FINAL
ENVIRONMENTAL IMPACT REPORT
HIGHLAND RESERVE NORTH
PLAN

**AN AMENDMENT
TO THE EXISTING
NORTH CENTRAL
ROSEVILLE SPECIFIC PLAN**

FINAL
ENVIRONMENTAL IMPACT REPORT

State Clearinghouse Number 96062065

FIGURE 2-17

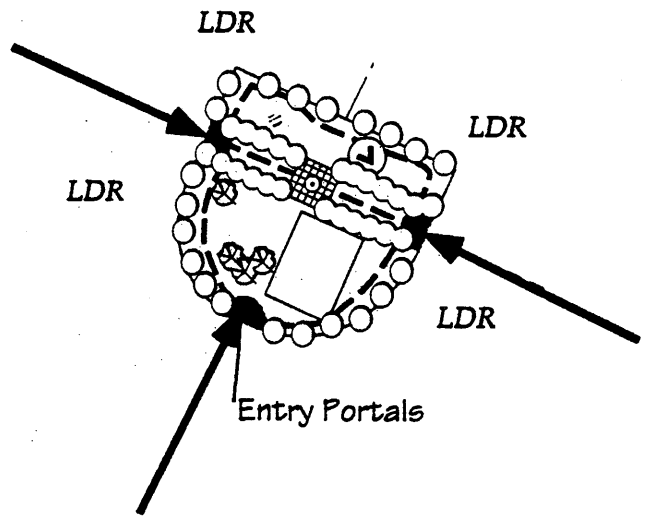
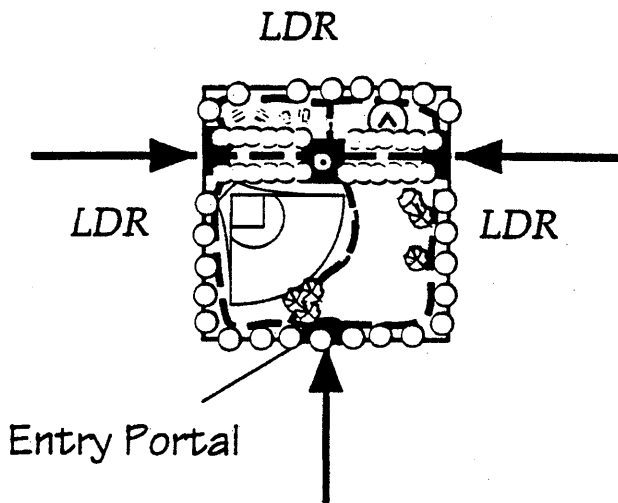
- 6) Figures 2-16 and 2-17 need to be revised to reflect revised park sizes and configurations. 6-6
- 7) Page 3.3-14, Local Setting paragraph: Reference to Vencil Brown Park scheduled to open in October 1996. Correct to read "The park *opened* in October 1996". 6-7

Response No. 6-6: The EIR has been modified to include the attached figures, Figures 2-16 and 2-17.

FIGURE 2-11

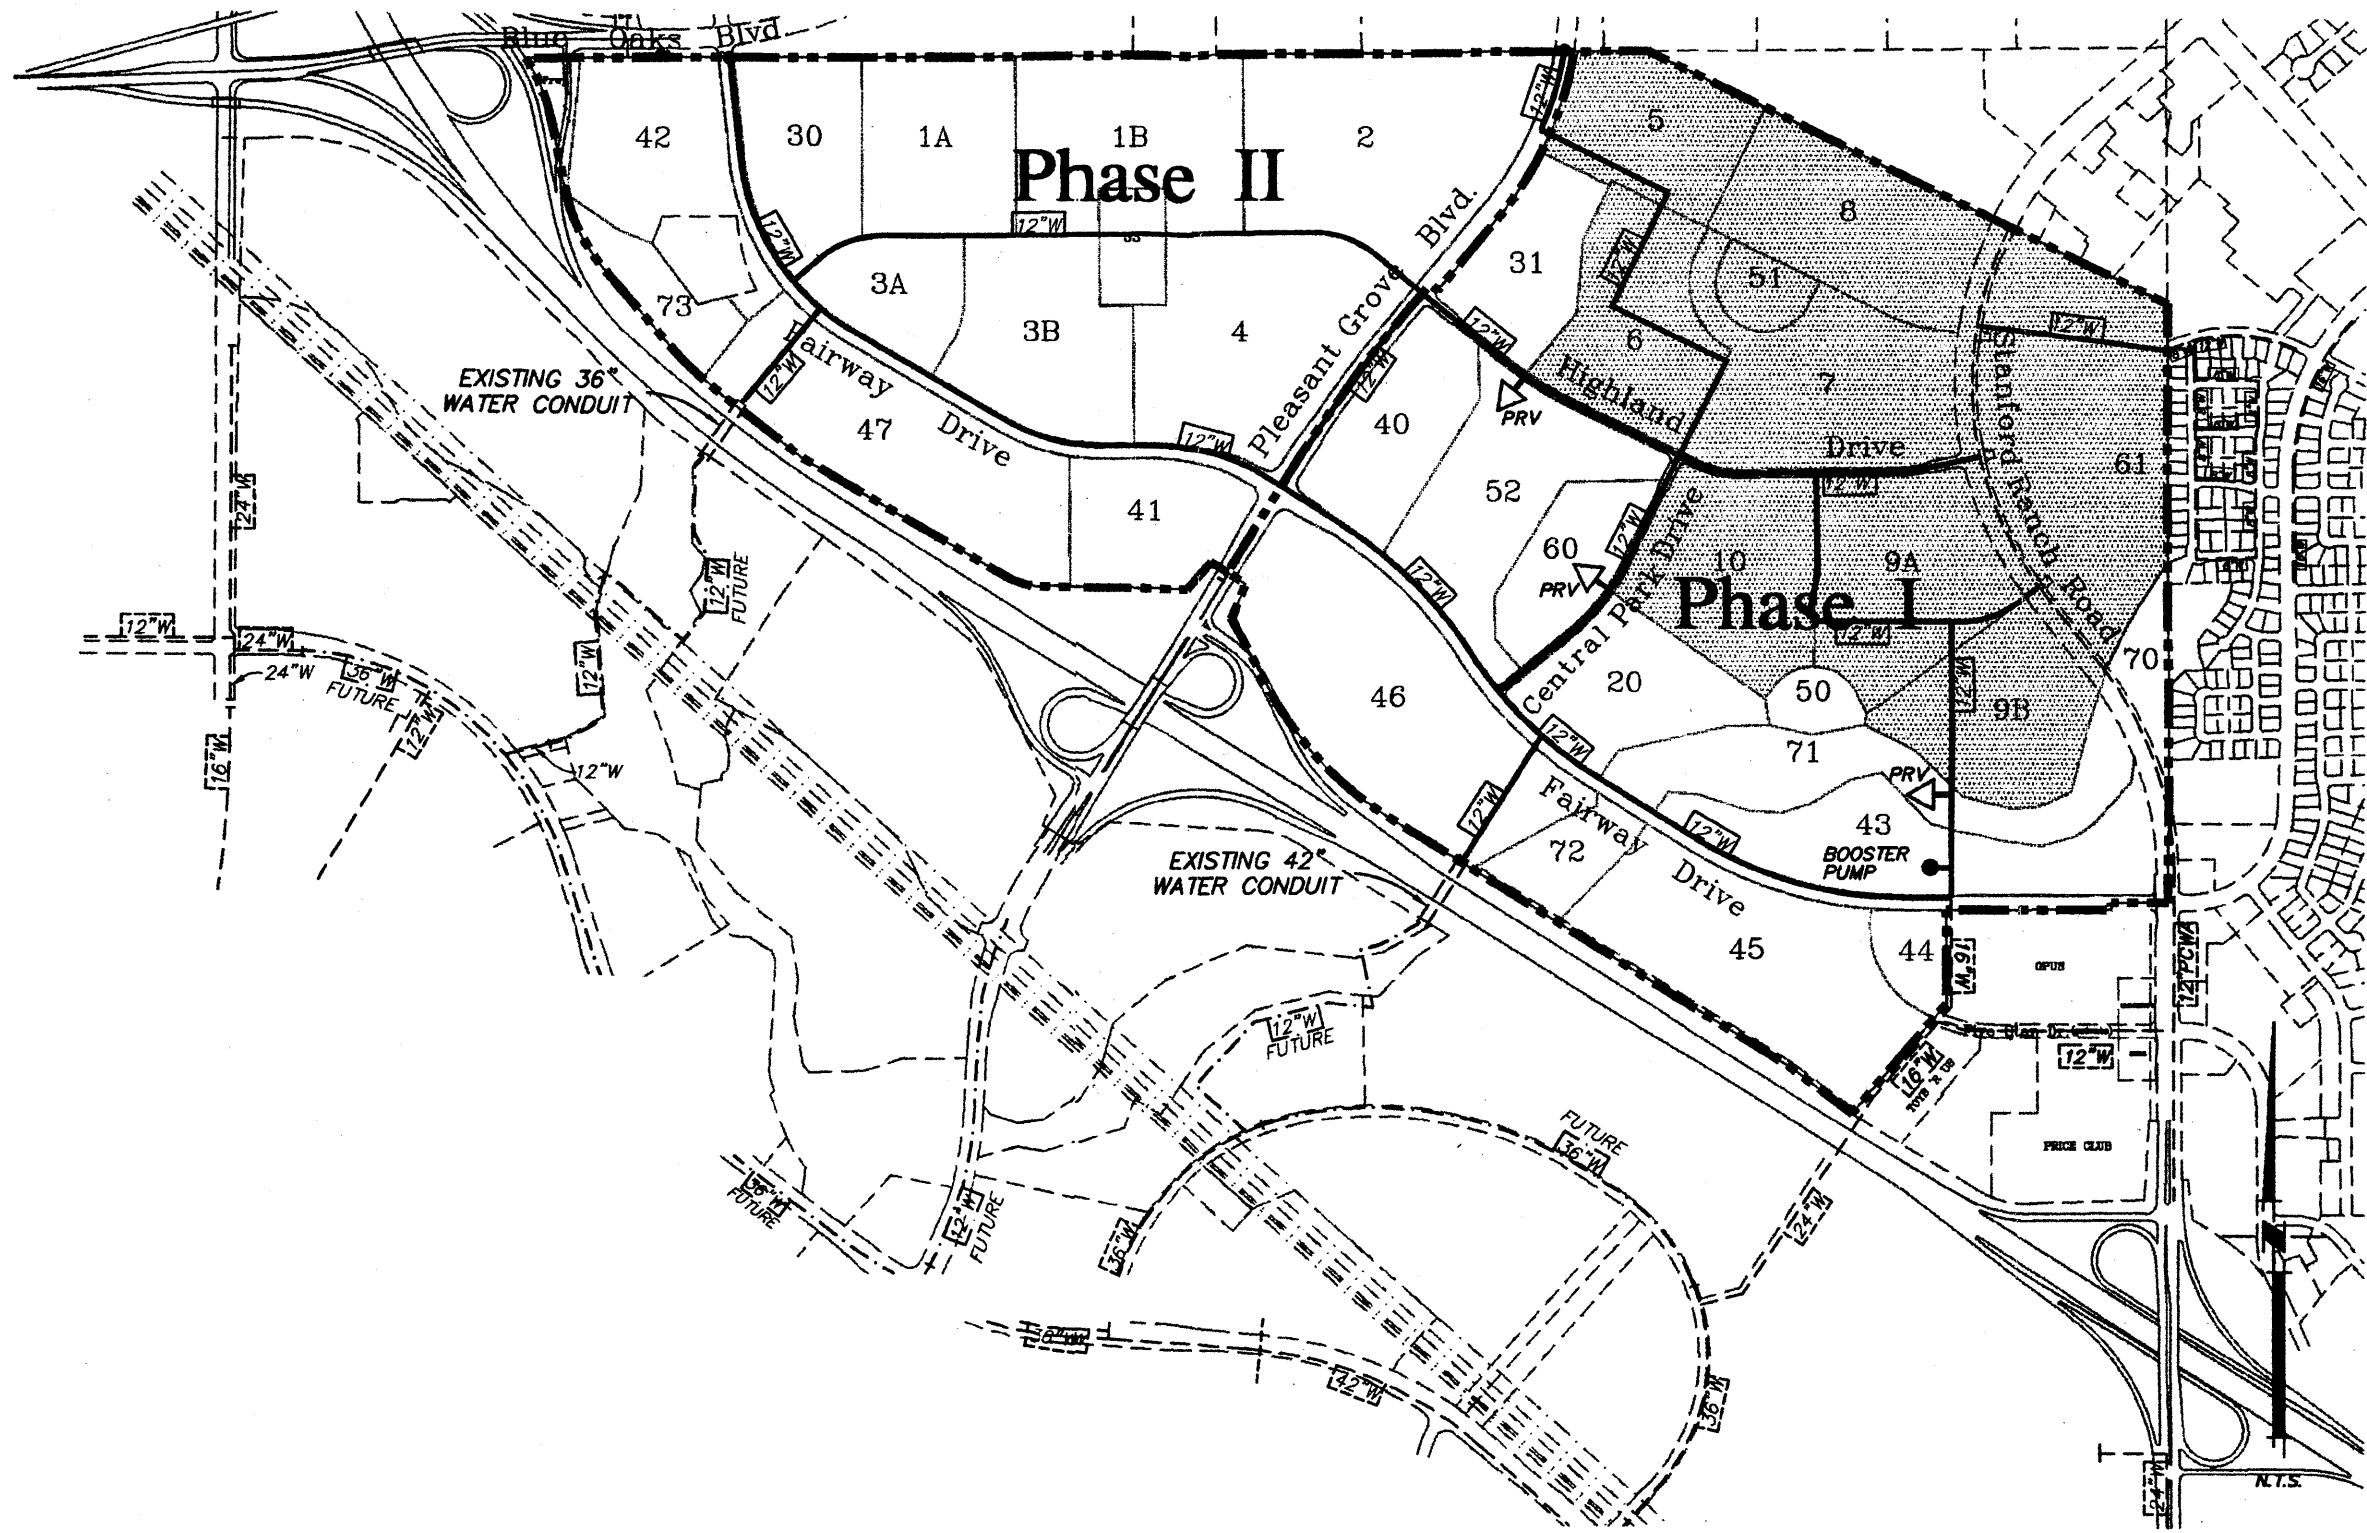
1. Figure 2-11, City Water Supply Option - Update to reflect the entire area that is contained in the higher pressure zone as well as improvements necessary to serve this area. 15-1
2. Figure 2-12, PCWA Water Supply Option - Update to reflect the entire area that is contained in the higher pressure zone as well as improvements necessary to serve this area. 15-2
3. Page 3.3-2, Local Setting 15-3
 - a) 24" waterline 1,600 feet east of Washington is a planned line and not currently existing for water feed to HRN.
 - b) 24" waterline off Gibson has been reduced to a 12" waterline in revised HRN layouts.

Response No. 15-1: Comment noted. An updated Figure 2-11 follows this page.
